**PLANNING DIVISION REPORT  
DEPARTMENT OF PLANNING AND COMMUNITY  
AND ECONOMIC DEVELOPMENT**

**October 28, 2008**

**RE: I.D. #12463, Demolition Permit – 902 Dempsey Road and 510 Cottage Grove Road**

Broken rail on exterior of Shop Building, May 2008

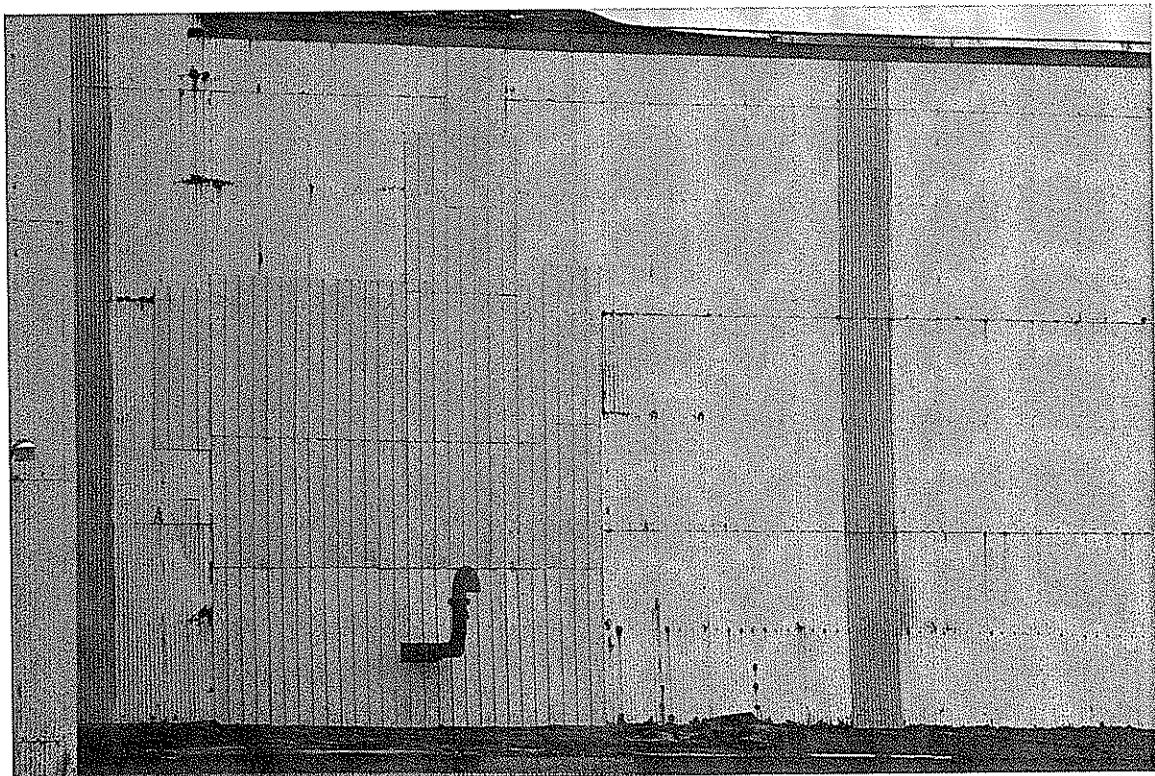
I have attached a number of pictures that show where trespassers breach the fence to enter the property and show some of the conditions of the granulation and shop buildings.

Top of granulation building with graffiti, May 2008

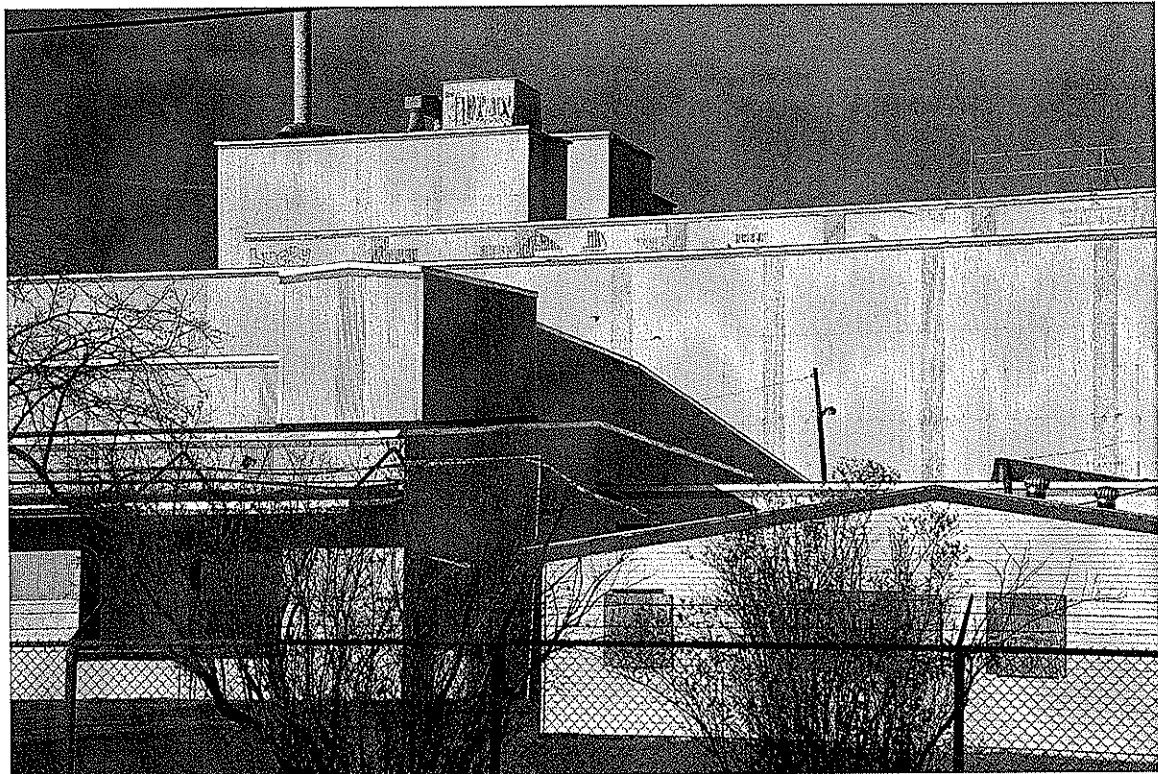
One Official Notice was issued on August 5, 2008 to remove graffiti from the granulation building by August 27, 2008. Two citations have been issued on this case and the graffiti has yet to be removed.
